UNITED STATES OF AMERICA
NUCLEAR REGULATORY COMMISSION

TEXAS UTILITIES GENERATING
COMPANY, et al.

(Comanche Peak Steam Electric Station
Station, Units 1 and 2)

CASE'S MOTIONS REGARDING ANI DOCUMENTS

Sec. A-A

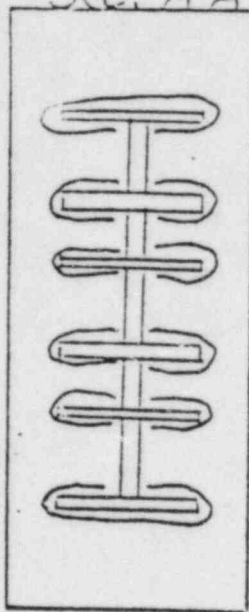
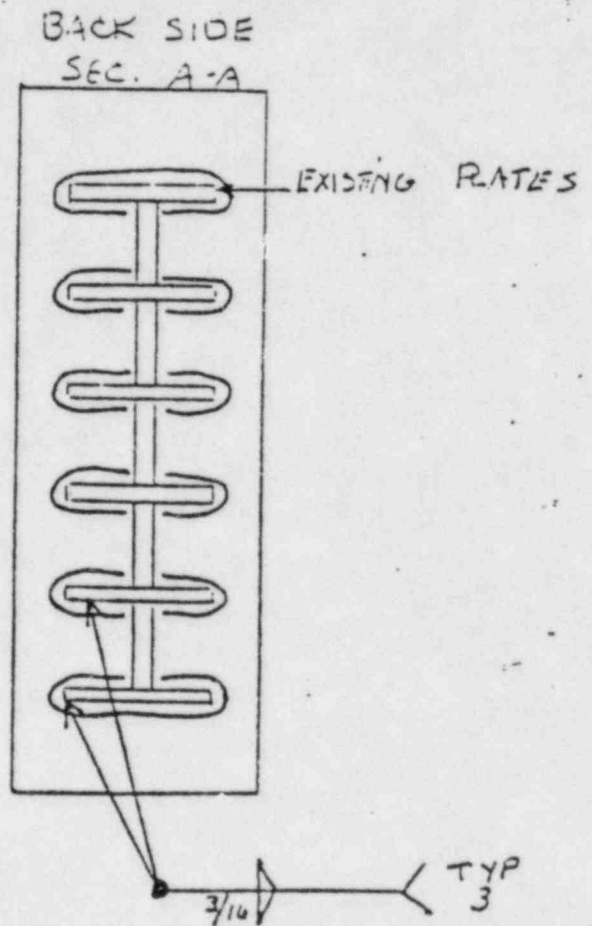
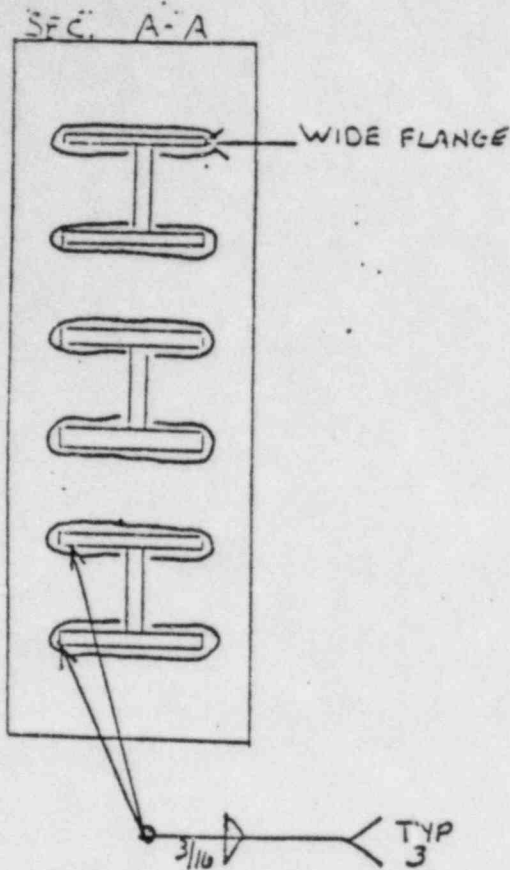
THE FOLLOWING HANGERS ARE WELDED AS SHOWN ABOVE

SUPPORT NO. CC-1-041-723-EC
SHEET 1 OF 2 REV. 1

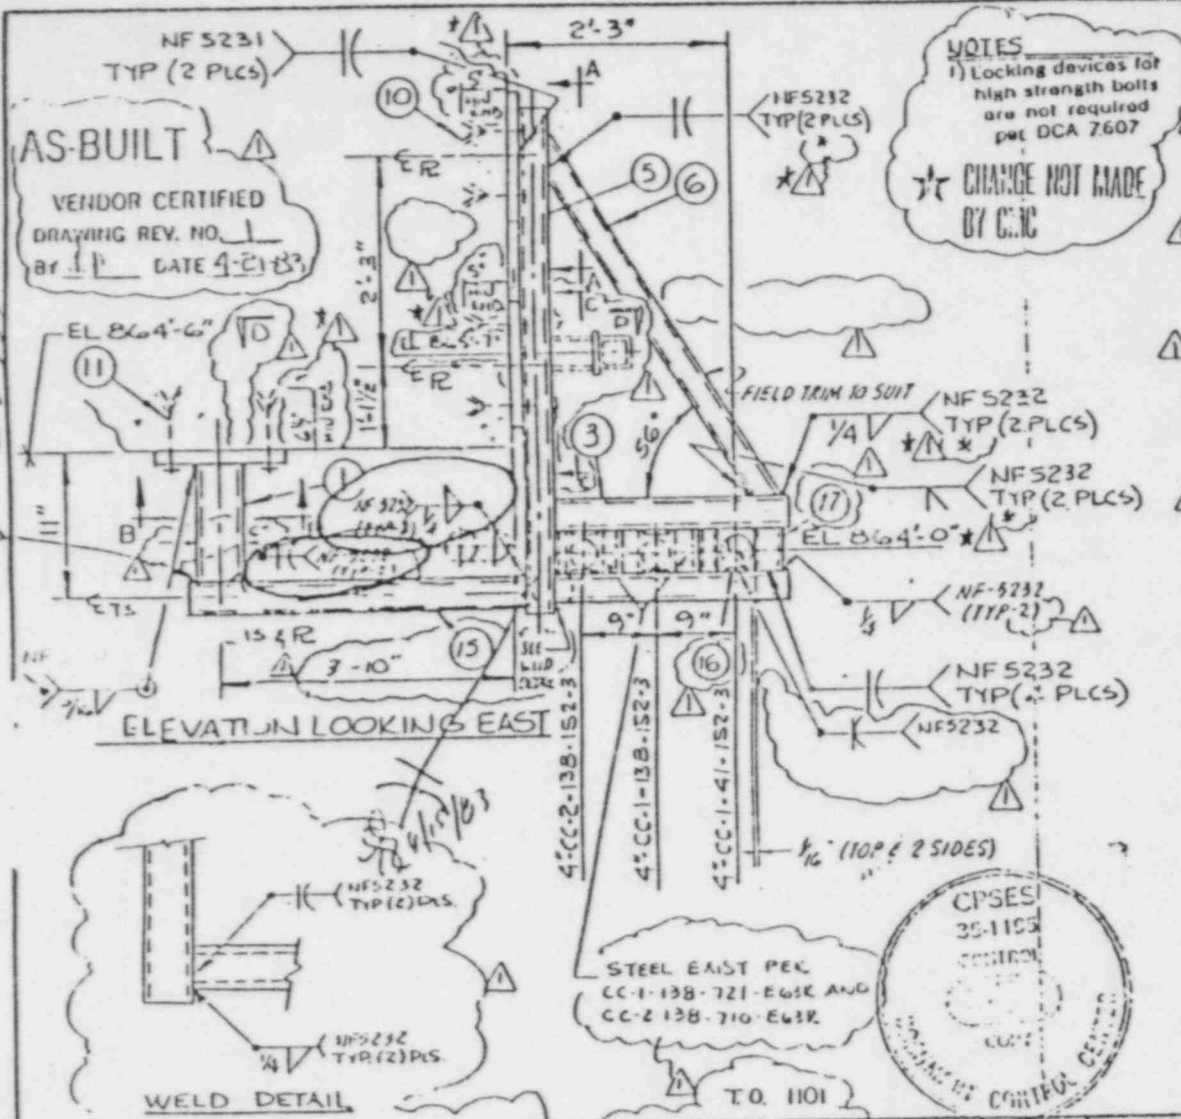
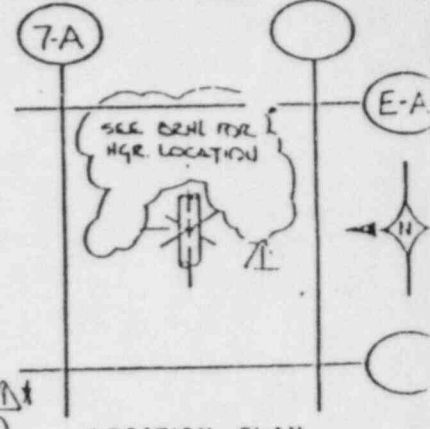
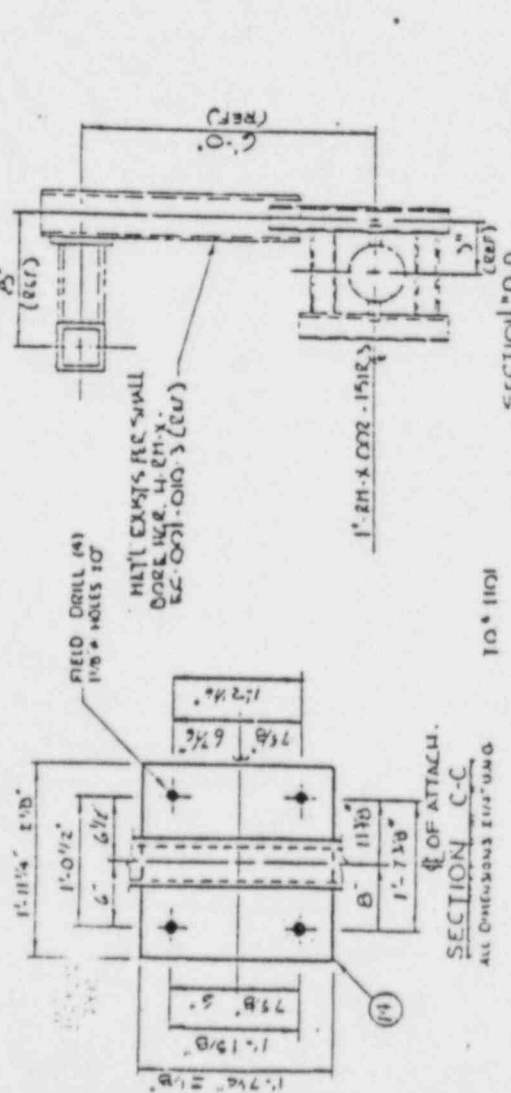
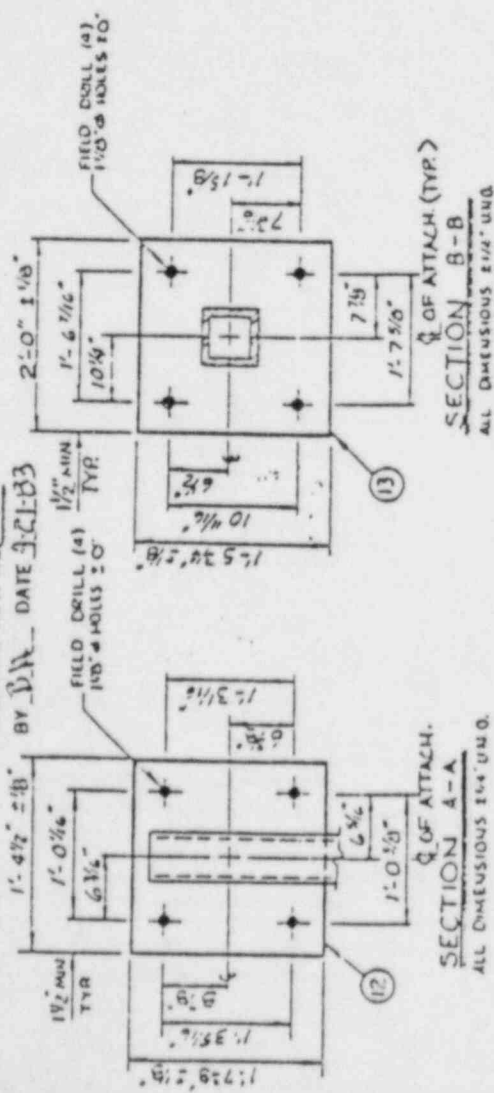
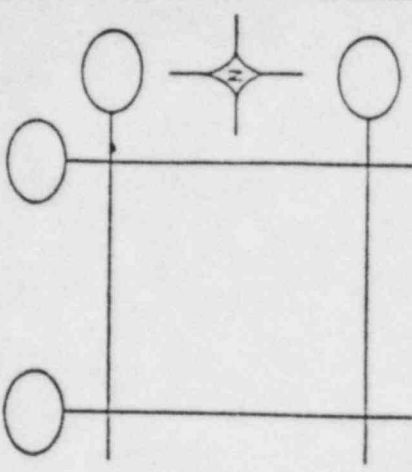
I share your concern over the rather flippant response provided by Engineering, relative to your observation on drawing CC-1-041-723-E63R. I have discussed this matter with Project and Engineering Management, who have reinforced the policy that Quality Engineering is the proper interface between the ANIA and other Project organizations.
